**Product Title**

**263-02156-00 MOTOR ASSY,DC**  
**933-14005-00 MOTOR,DC,SHUTTLE ROTATE****Details**

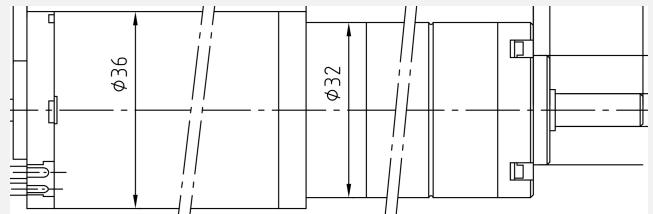
The exact same motor gearbox 93:1 for Robot Rotation/Extension and 308:1 for the Shuttle platform rotation are still used. The motor has a little larger in Dimension.

Effortless Installation: Upgrade hassle-free with our plug-and-play design. The new motors share the same size for installation, ensuring a smooth swap without any modifications or specialized tools.

To order use part numbers 263-02156-01 and 933-14005-01
